PCN/22/012/C+N-US

Product Range: Han-Modular®

Title: Han 200A Module Axial Screw mating side

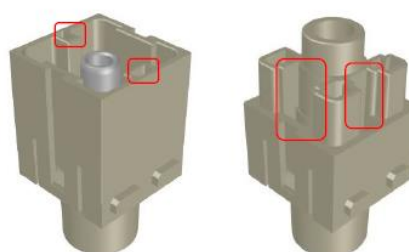
Improvement of the Han® 200A module axial screw mating side ensures mating compatibility with all other 200A and 300A modules.

The modified 200A axial module will also be backwards mating compatible with the present 200A axial module.

The changes are marked red at the below drawings.

The new 200A axial screw male module will get some additional depending, marked red.

Additionally, some outer edges will be smoothed a little to improve the handling.
